WELL API NO.	30-015-39344	
5. Indicate Type of Lease	STATE <input checked="" type="checkbox"/>	FEE <input type="checkbox"/>
6. State Oil & Gas Lease No.		
7. Lease Name or Unit Agreement Name	POKER LAKE CVX JV BS	
8. Well Number	007H	
9. OGRID Number	373075	
10. Pool name or Wildcat	WILDCAT G-015 S263001O-BONE SPRING	
11. Elevation (Show whether DR, RKB, RT, GR, etc.)

XTO Permian Operating LLC, respectfully requests approval for plug and abandonment of the above mentioned well. Please see the attached P&A procedure, with current and proposed WBD's for your review.

PLUG AND ABANDON WELLBORE  
 POKER LAKE UNIT CVX JV BS 007H  
 EDDY COUNTY, NEW MEXICO  
 Class II

Operator: XTO PERMIAN OPERATING LLC. 6401 HOLIDAY HILL ROAD MIDLAND, TX 79707	OGRID: 373075
	Action Number: 519272
	Action Type: [C-103] NOI Plug & Abandon (C-103F)

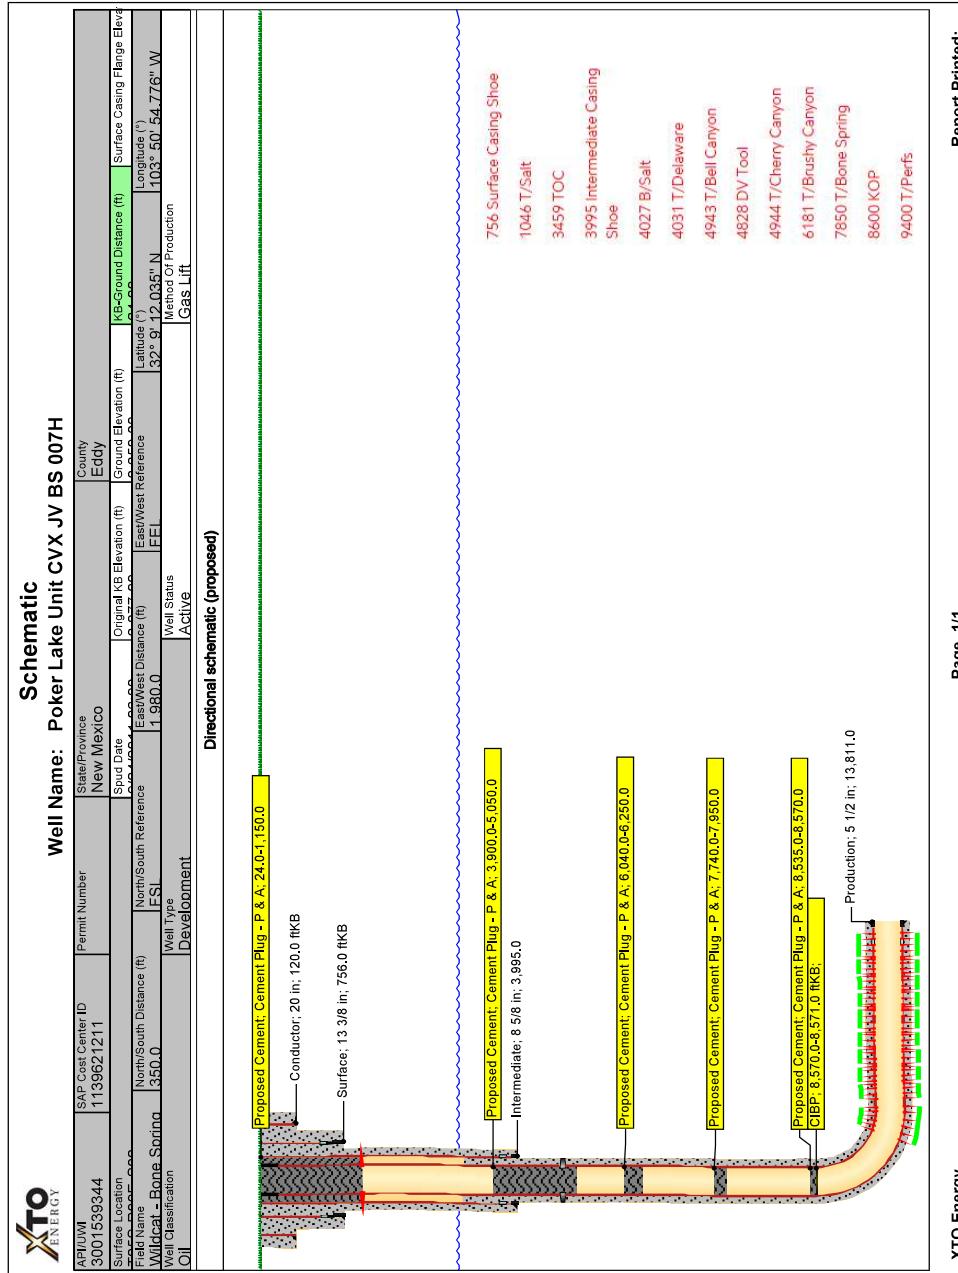
- 8) MIRU plugging unit company. Set open Steel Pit for plugging
- 9) ND WH and NU 3K manual BOP. Function test BOP.
- 10) Spot 25 SKS **Class H** cement from 7,950' to 7,740'. (T/Bone Spring)
- 11) Spot 25 SKS **Class H** cement from 6,250' to 6,040'. (T/Brushy Canyon) **6030'**
- 12) Spot 120 SKS Class C cement from 5,050' to 3,900'. WOC and tag to verify TOC. (T/Cherry Canyon, DV Tool, T/Bell Canyon, T/Delaware, B/Salt, Intermediate Casing Shoe)
- 13) MIRU WLJ, perforate at 1,150'.

APPROVED  
GC 10/29/25
